SERVICE INFORMATION

SERIAL NO. 9006

SUBJECT	Skipping
ITEM	Compact Disc Player
MODEL	DX-1500/DX-2500/DX-M70

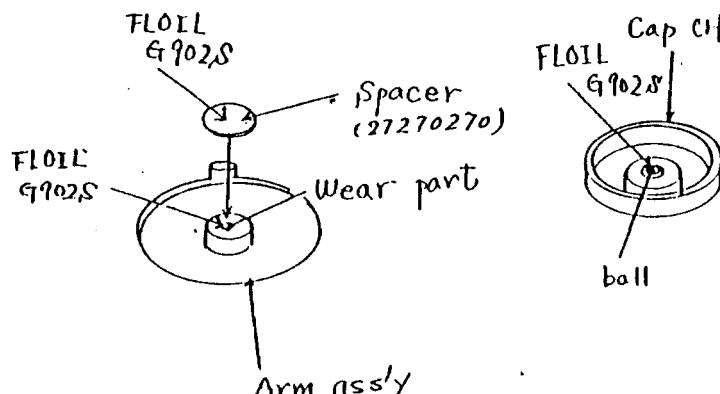
3. Confirmation of pickup slide mechanism

Remove the mechanism and apply 1V DC to the both sides of the slide motor terminal.

Does the pickup go to the outermost position without getting stuck?

If not, replace the slide motor.
